Amendments to the Drawings:

REMARKS

FIG. 2A

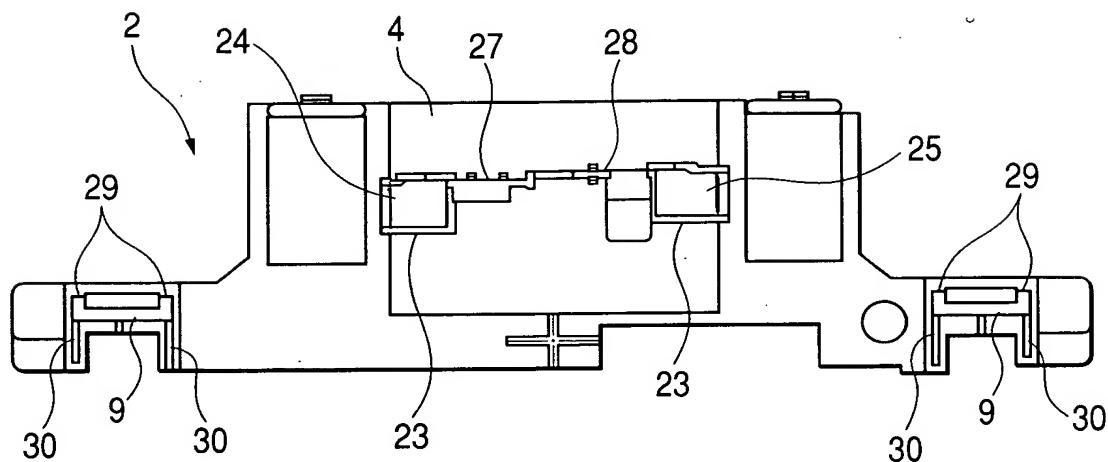
Please approve the changes to the drawings, which include the additions to table portion 4 extending beneath the battery terminal holder portions 24, 25 in Figure 2A, as shown in red on the marked-up copy. Corresponding replacement sheet formal drawings are also being submitted concurrently.

With regard to the Examiner's objection to the drawings as failing to comply with 37 C.F.R. §1.84(p)(4), please note that in Figure 2A the battery terminal boards 5, 6 shown in Figure 1 are indicated at page 4, line 16 as not shown in Figure 2A, only the ribs 23 formed on the table portion 4 that surround the battery terminal holder portions 24, 25 which serve to position the battery terminal boards 5, 6. That is, the edge of the battery terminal boards 5, 6 where shown is coincident with the edge of ribs 23 and covers the terminal holder portions 24, 25. Thus, there is no inconsistency in reference numbers. However, where the battery terminal boards 5, 6 are not shown in Figure 2A, lines representing an edge of the terminal holder portions 24, 25 (vertically coincident with an edge of aperture 26) was inadvertently omitted and the requested drawing correction supplies these lines. Support for this amendment can be found in the specification at page 4, lines 14-22. Accordingly, proposed drawing corrections are being submitted concurrently herewith. Approval of the drawing correction and withdrawal of the drawing objection is respectfully requested.
